Customer: RALEC KUNSHAN **Date:** 20-Jun-17 **Time:** 10:00

Explained on MARUWA's action n THRU HOLE SHIFTED for product WA04-2C

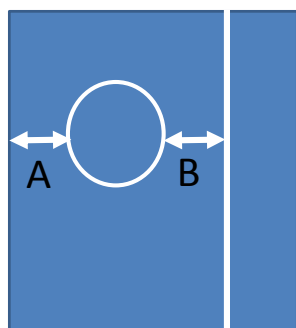
Meeting started of with Quality group.
For RALEC, the only problem to be solve is on thru hole shifted

1. Automation measurement on green sheet. MARUWA can increase the sample size for guranting the each coil
2. Outgoing confirmation for bigger sample size. (Sourcing of machine)
3. Mould change from MANUAL PRESS to AUTO PRESS - **AUG'17 SHIPMENT**

Confirmation of measurement method

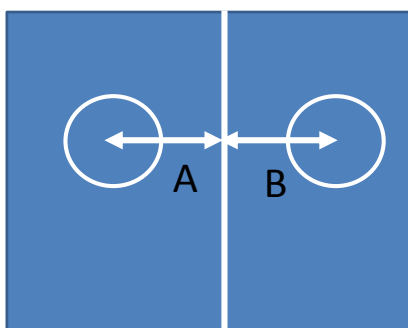
The difference between RALEC & MARUWA measurement is

RALEC: Focus hole position from the edge (inner diemanion)

MARUWA : Hole position with Slit
